PC Case# PC25-05	Date Received: 7/8/2025
Reviewed By: ES	PC Meeting Date: 8/25/2025
Council Meeting Date: 9/18/2025	Date of Legal Publication: 8/13/2025
Fee: \$ 1,080.00	<input type="checkbox"/> Cash <input type="checkbox"/> Credit Card <input checked="" type="checkbox"/> Check # 21277

RE: Review of Final Plan / Construction Drawings
Northwood Estates Subdivision – Section 1

The Kleingers Group has reviewed the Final Plan / Construction Drawings for Northwood Estates Subdivision Section 1 by Choice 1 dated July 7, 2025 and have the following comments/observations:

R E: REQUEST FOR A PRELIMINARY & FINAL SUBDIVISION PLAN FOR NORTHWOOD ESTATES SECTION 1 SUBDIVISION

NORTHWOOD STATES SUBDIVISION - SECTION 1
CITY OF CLAYTON
STREET AND UTILITY PLAN

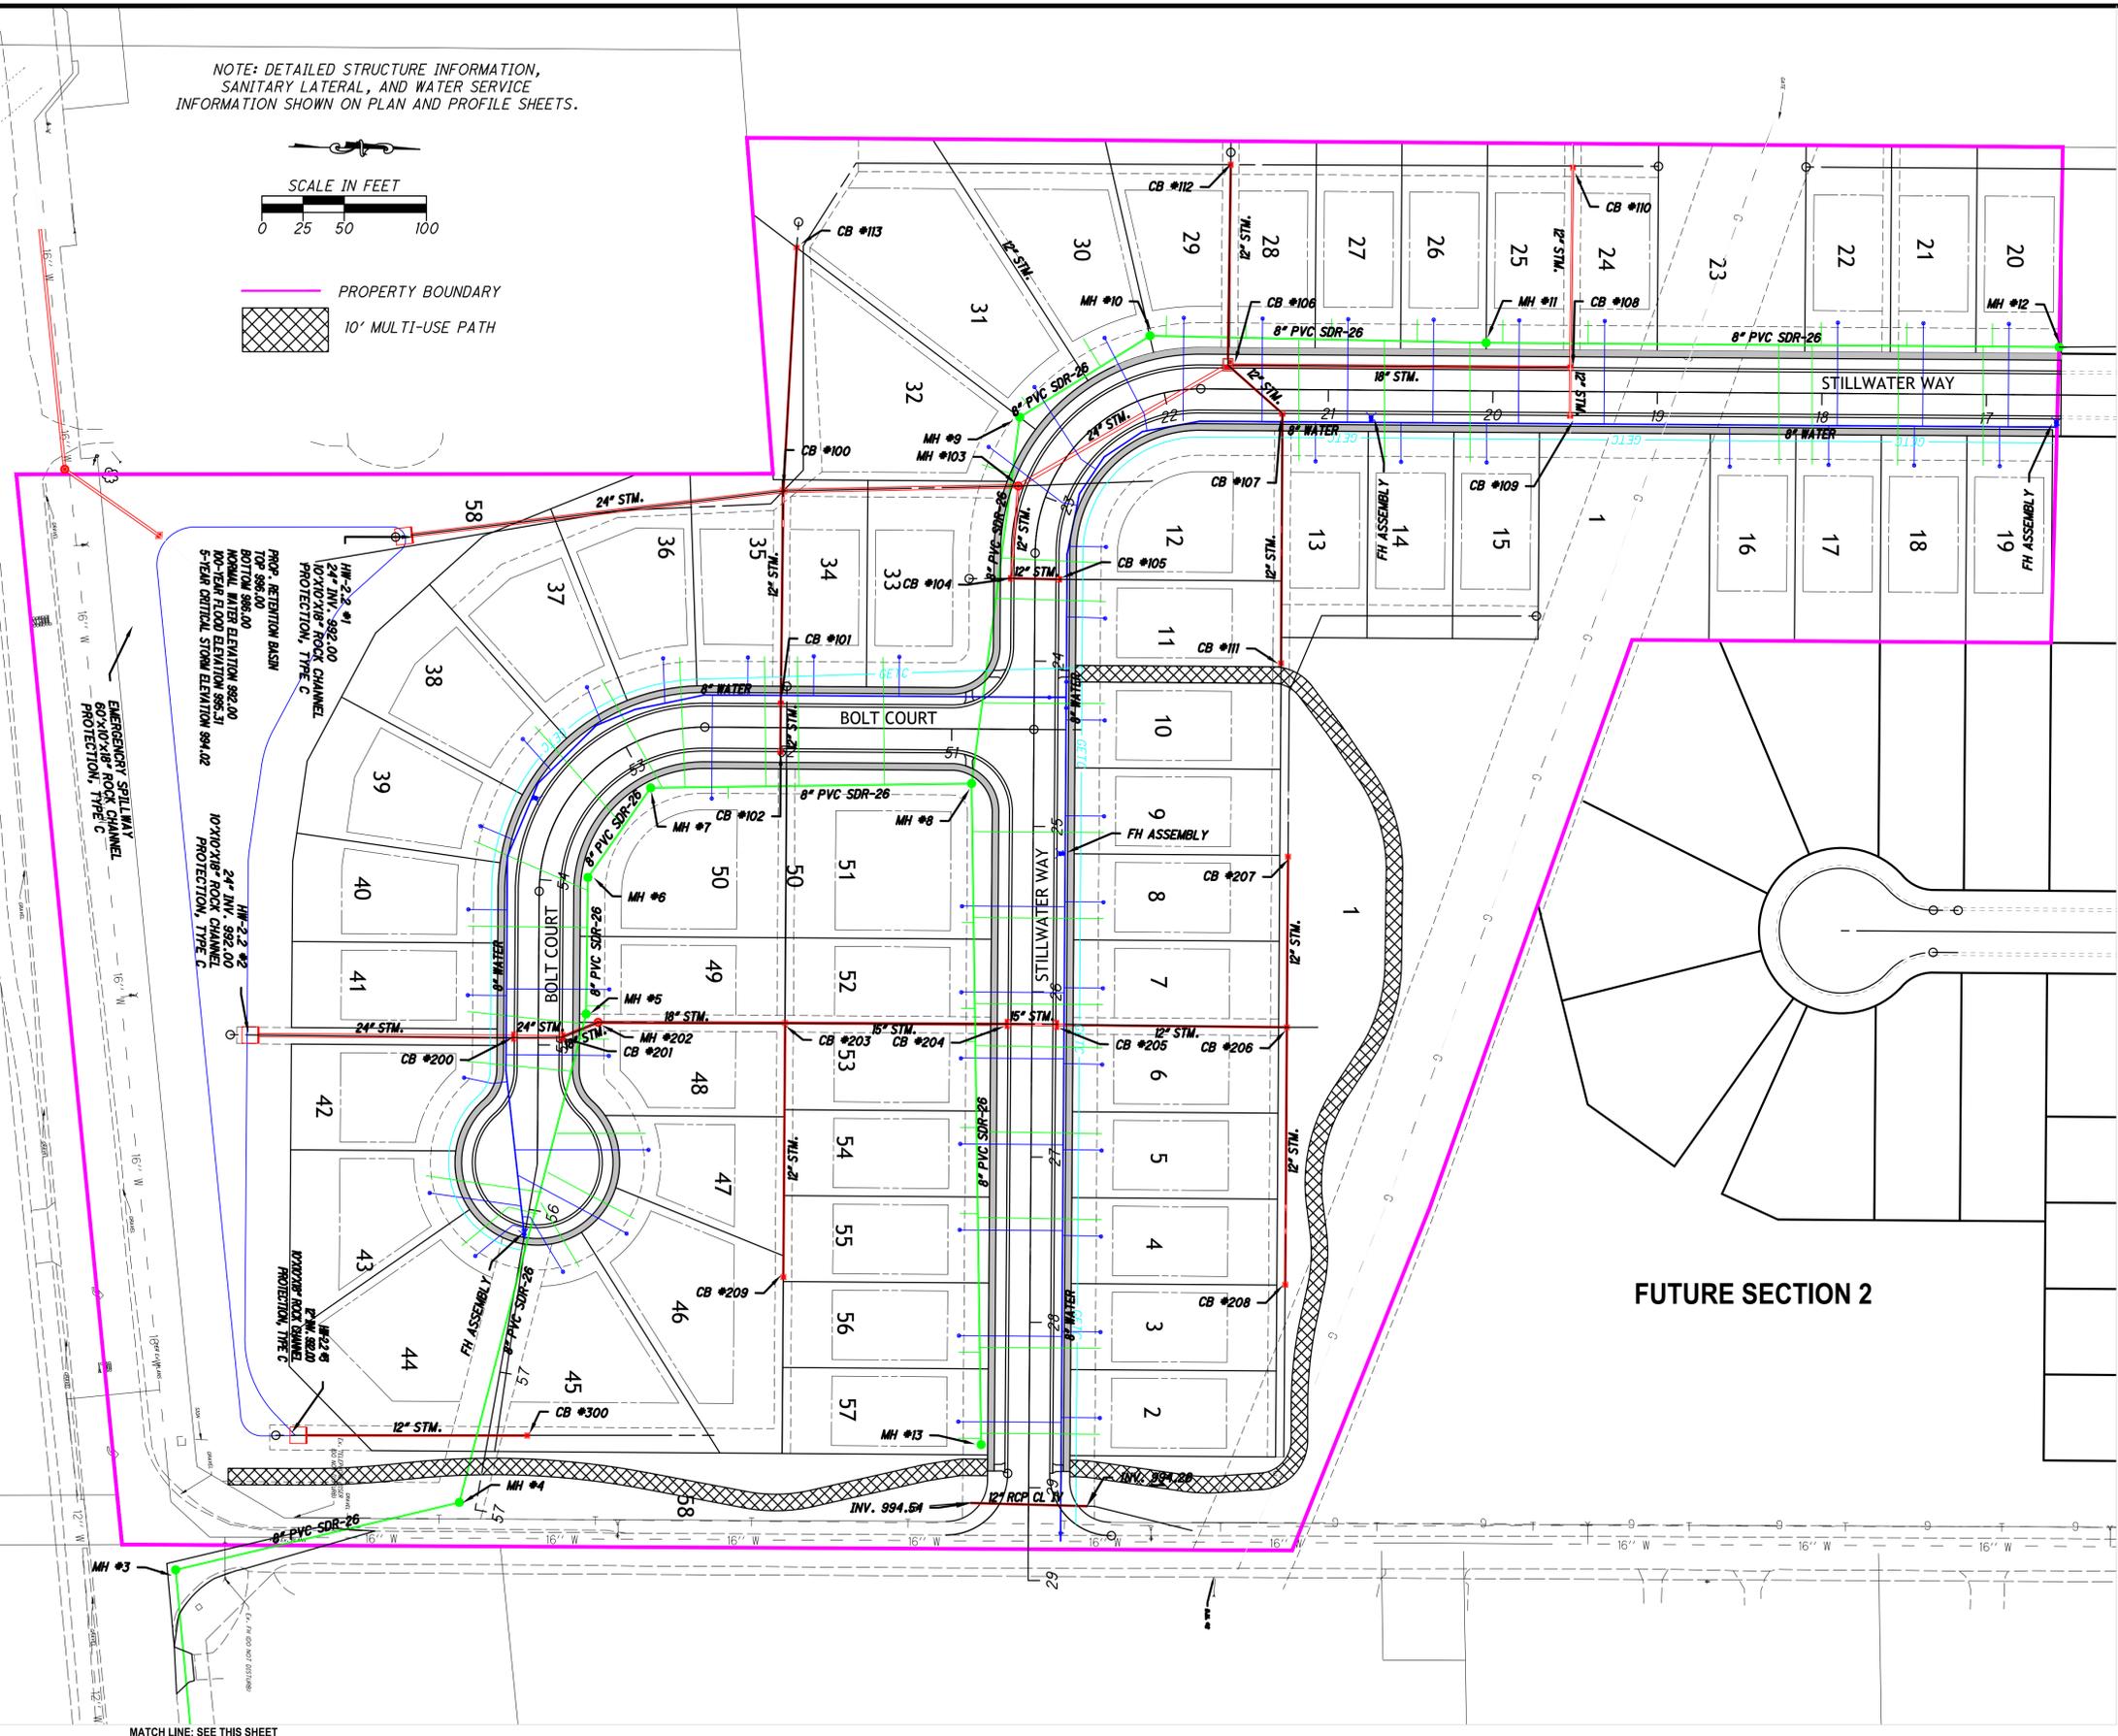
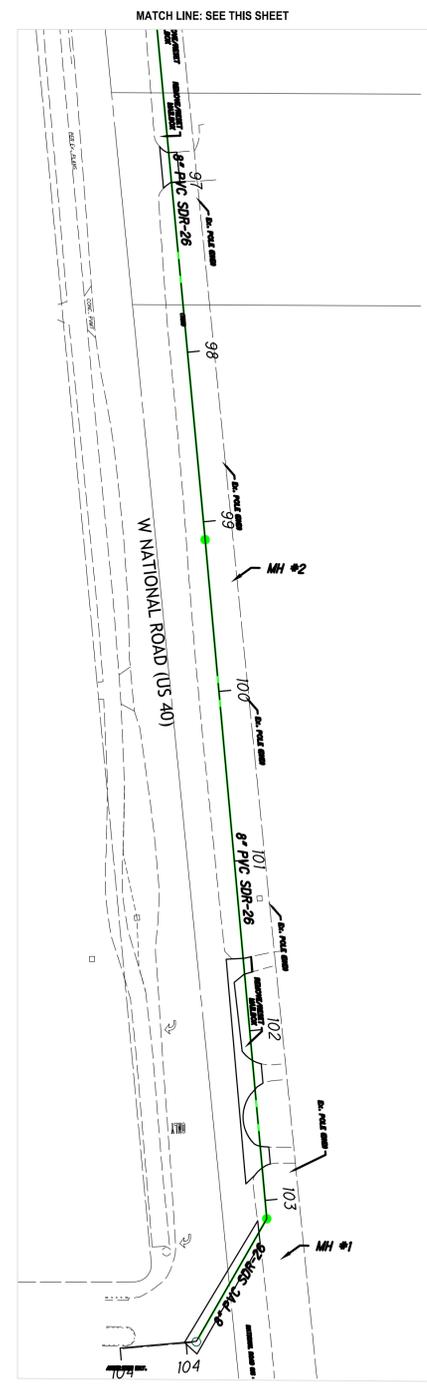
Street and Utility Plan (7)

8. There appears to be a conflict with an existing storm sewer within the right of way of US40. How is existing roadway swale being collected if a manhole is replacing the pipe opening prior to the driveway?
9. Previous reviews of the Traffic Impact study mention how the Multi Use Path should be addressed within the intersection of Haber and US40. Some thought should be given to showing an connection to the existing path on the south side of US40.
10. Add Major Roadway Names to the main drawing on the sheet.

NORTHWOOD ESTATES SUBDIVISION - SECTION 1
CITY OF CLAYTON
GRADING PLAN

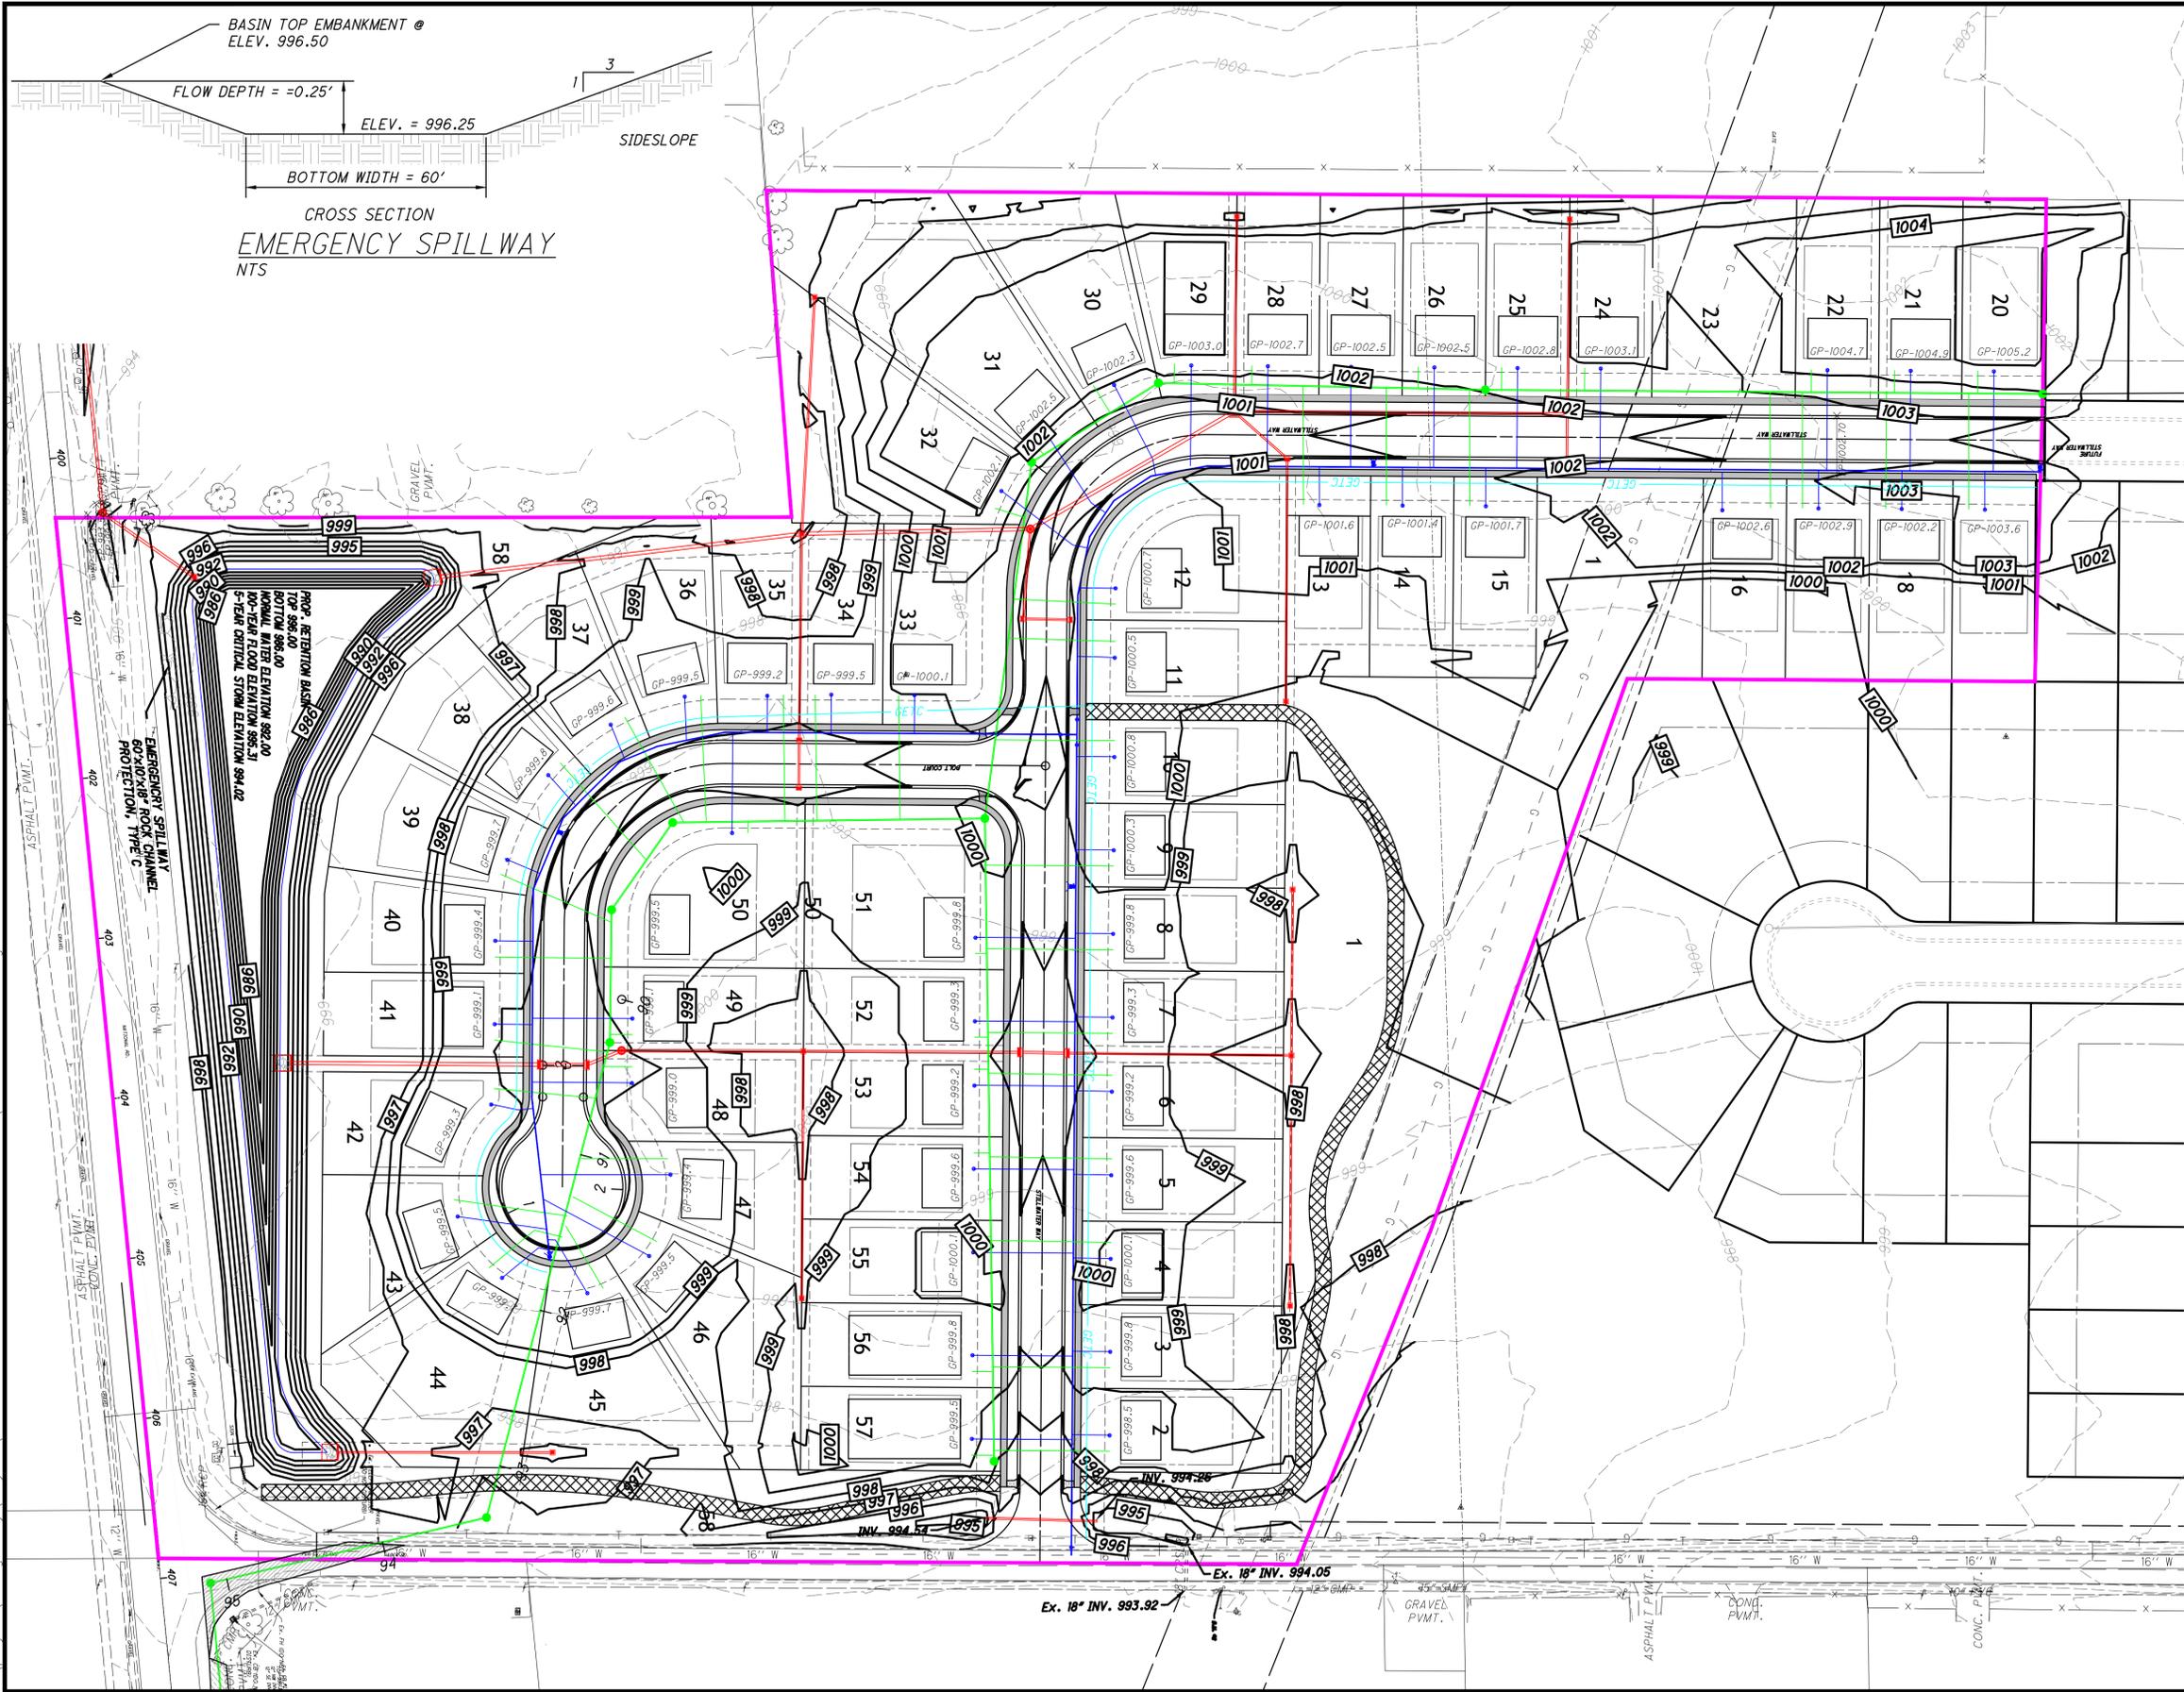
Grading Plan (8)

11. There are two sheets in the set with this label.
12. Emergency Spillway cross section cuts off grading detail to creek.
13. The 999 elevation label on the west side of the detention pond is placed over the 998 contour line.
14. A detail should be given to the swale from the outlet of the pipe under Stillwater Way to the pipe invert receiving the flow.
15. Flood Routes and typical sections for those swales should be shown.

FILE NAME	GP001
DRAWN BY	KMM
CHECKED BY	NNS
PROJECT No.	MOTCLA2504
DATE	7-7-2025
SHEET NUMBER	12 OF 19

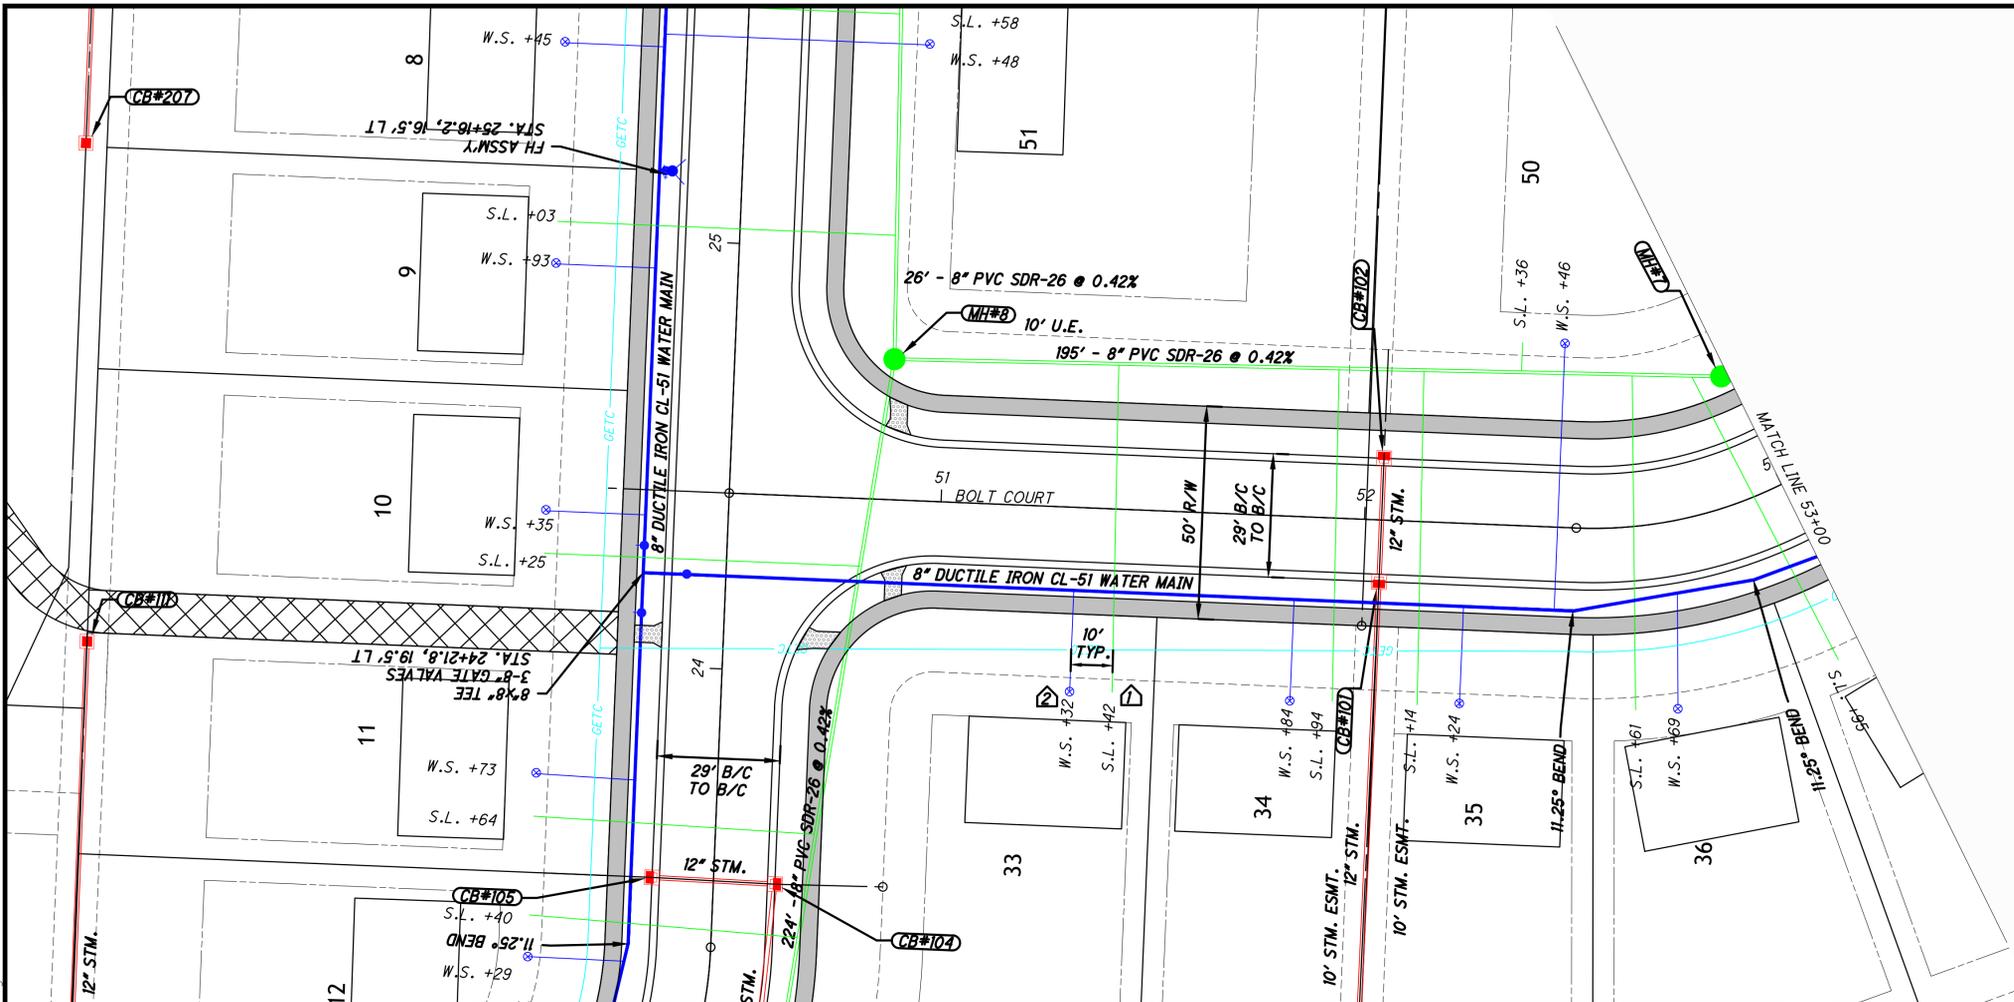
21. All waterline bends and valves need to be stationed.
22. Show pipe invert of 18-inch pipe under Haber Road on Sheet 12. Verify the condition of the pipe.
